801

2115 / 2121 WESTLAKE AVE
SEATTLE, WA 98121
PROJECT # 3037037 - EG

EARLY DESIGN GUIDANCE 2
DATE: 7/6/2021

ITEMIZED RESPONSE TO EDG #1 - BOARD RECOMMENDATIONS

CONCEPT 5_FULCRUM

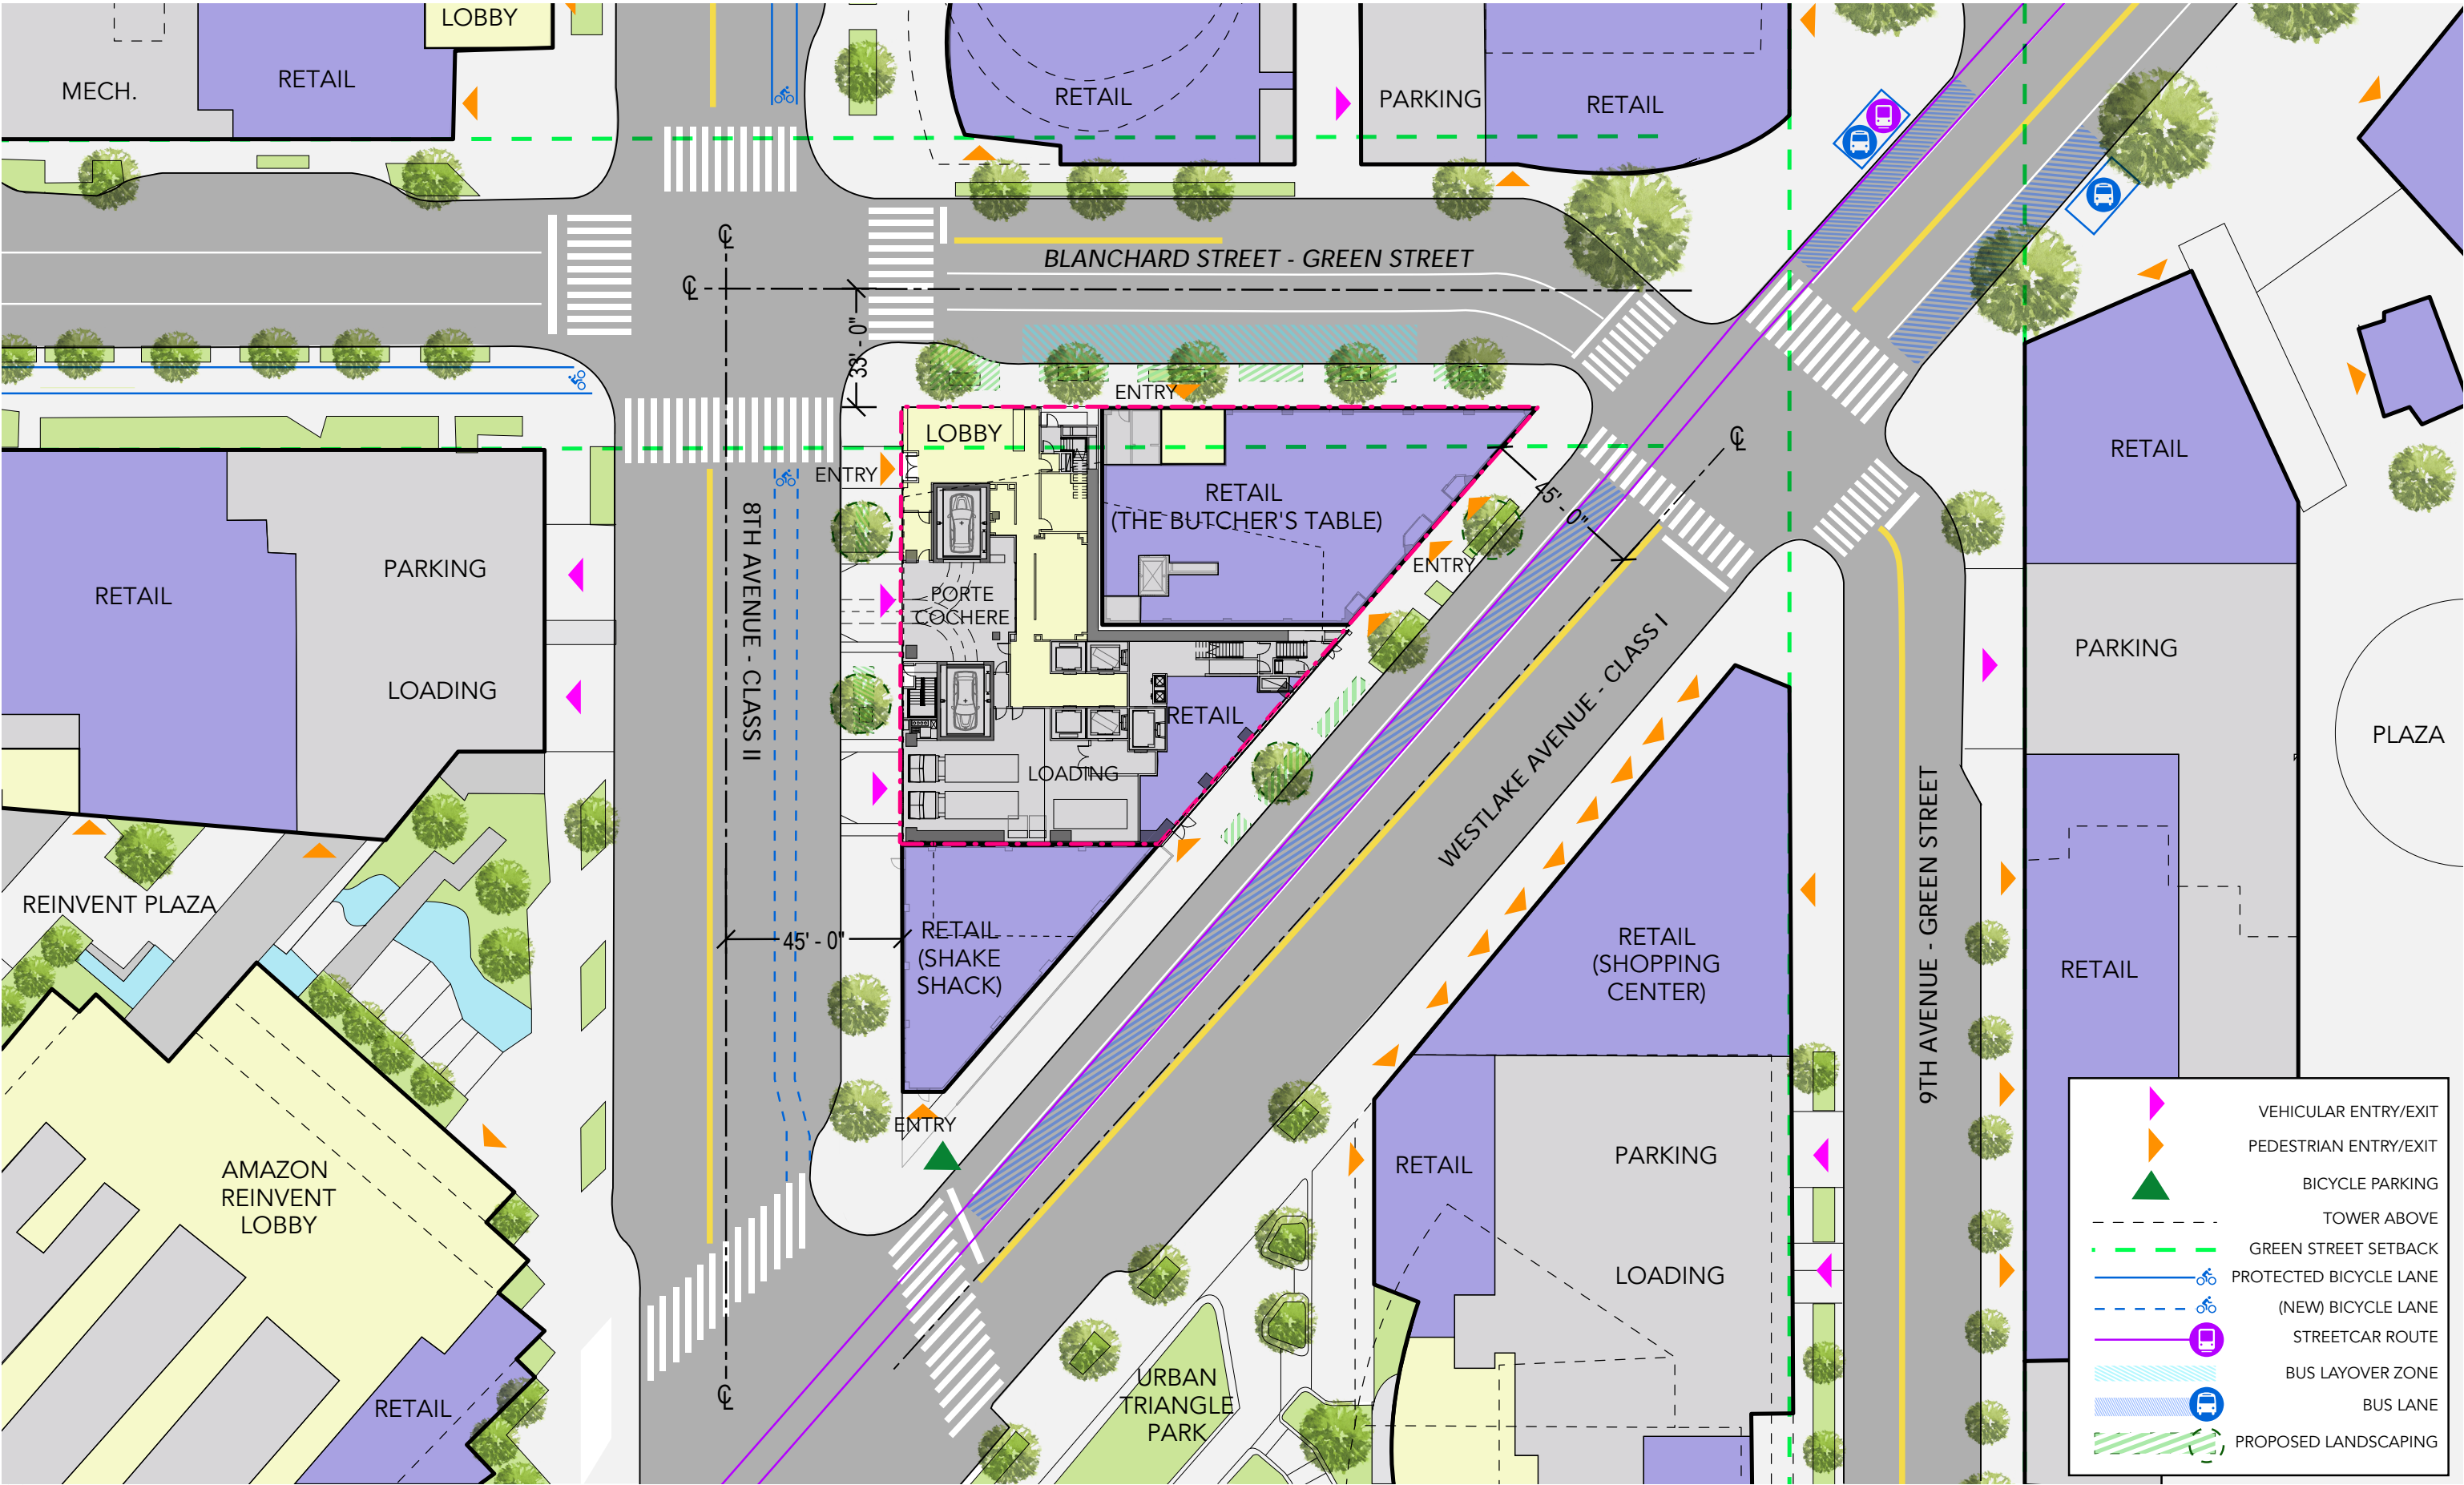
e.	e. The Board noted that the base of Option 1 and Option 3 better responds to the horizontal datums and scale of existing development along Westlake Ave and at the west corner, whereas Option 2 reads as a continuous flat plane from top to bottom. The Board recommended further study of how the scale of the base responds to the neighborhood context, is informed by the overall concept, and highlights the corner entry. (B-1, B-2.2, B-3, B-4)	<p>In both Massing Concepts, the base building shape is aligned to horizontal intervals of the existing buildings on the block. (B2.2) The western facade features a roof line aligned to the Butchers Table cornice and a belt course which continues the Shake Shack 1-story datum. (B-2.2.h.; B-3.2)</p> <p>In Concept 5, to further mitigate the bulk of the tower at the base, the facade is gradually modified with deeper recesses and expressed frames (B2.2h.; B-2.3.n.) modulated in sizes similar to the existing buildings.</p>

-Preference for horizontal datums matching existing buildings on the block

-Overhead weather protection should be integrated

The base of the building emphasizes horizontal intervals relating to the existing buildings on the block. **(B2.2)** The western facade features roof line aligned to the Butchers Table cornice and a belt course which continues the Shake Shack 1-story datum.

(B-2.2.h.; B-3.2) To further mitigate the bulk of the tower at the base, the facade is gradually modified with deeper recesses and expressed frames **(B2.2h.; B-2.3.n.)** modulated in sizes similar to the existing buildings.

Overhead weather protection is provided at pedestrian entries with on 8th and Blanchard, and on Westlake to align with the Shake Shack's adjacent canopy feature. **(B3.3 C-5)**
